Access Compliance Report Public Rights-of-Way (Pedestrian Signals)

Main Street: **IRVINE_BLV** Cross Street: **RED_HILL_AVE** Location: **NE**

ADA ID: **SGAT211021143953** Signal Type: **One Push Button-APS** Overall Compliance: **No** Severity Scores: **BTN 1: 25** **BTN 2: N/A** **No BTN: N/A**

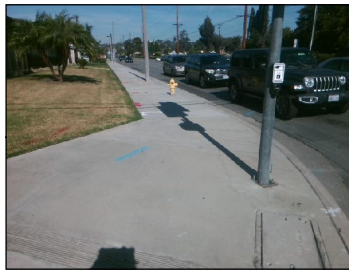
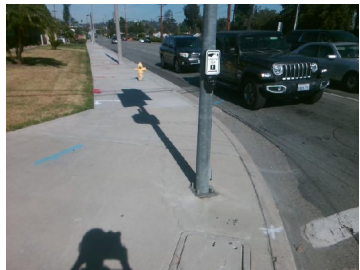
OC Std/PROW: **R404.2, R404.3**

Possible Solutions: Remove and Replace Clear Space.
